SUBJECT: STAFF OBSERVATIONS OF ARKANSAS NUCLEAR ONE, UNIT 2,
STRAINER TESTING FOR GENERIC SAFETY ISSUE 191 DURING
AUGUST 13–14, 2007, TRIP TO FAUSKE AND ASSOCIATES
(TAC NOS. MC4663 AND MC4664)

NRC STAFF TRIP REPORT
HEAD LOSS TESTING FOR ARKANSAS NUCLEAR ONE, UNIT 2
AT FAUSKE AND ASSOCIATES
(TAC NOS. MC4663 AND MC4664)

Figure 1: Idealization of the Impact of Boreholes on Measured Head Loss

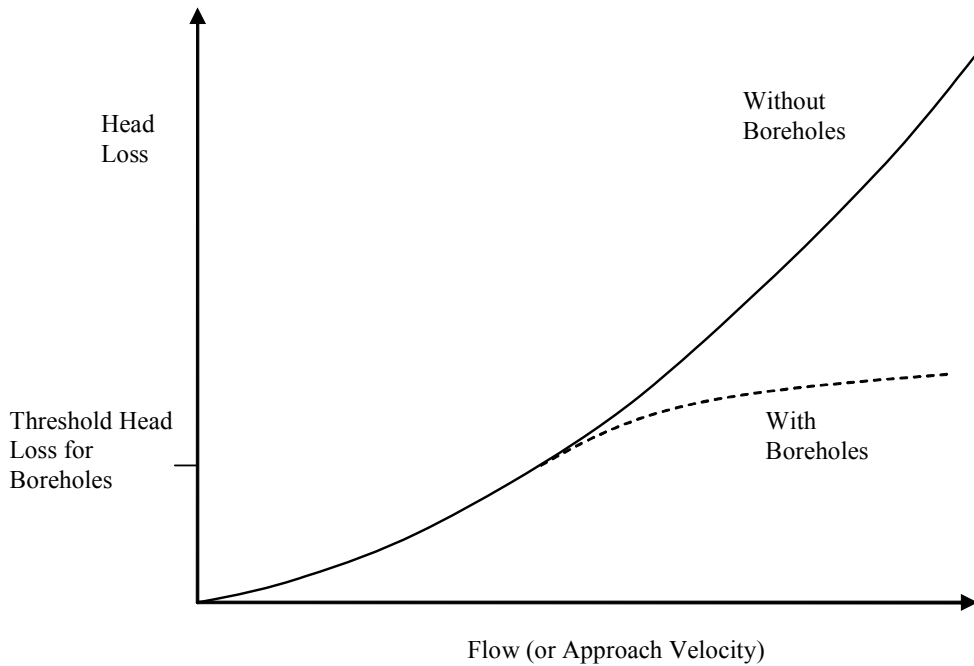
2. The head loss from the "ultra-thin bed" observed during the test was limited due to the formation of boreholes through the thin debris layer. When the extra debris batches were added following the official completion of the test, the increase in head loss resulted in the uncovering of the downstream side of the test strainer, which allowed visual observation of boreholes forming in the debris bed. However, the licensee also conducted flow variations when the downstream side of the strainer was submerged. The unexpectedly small changes in head loss associated with the flow variations indicated that borehole formation was occurring, even though the presence of boreholes was not visually identifiable. The licensee further stated that during one test, after the flow was cut in half, the measured head loss recovered to approximately 90 percent of its original value. The licensee's test observations are significant in suggesting that, in a flow regime where borehole formation limits the head loss across a debris bed, reducing the flowrate through the debris bed (i.e., throttling or shutting off pumps) may result in only minor reductions in the measured head loss, as compared to a debris bed for which the head loss is not borehole limited (for which the head loss generally varies with flow slightly more than linearly in the regime of interest to most pressurized-water reactor replacement strainers). An idealized diagram illustrating this phenomenon is provided below as Figure 1.
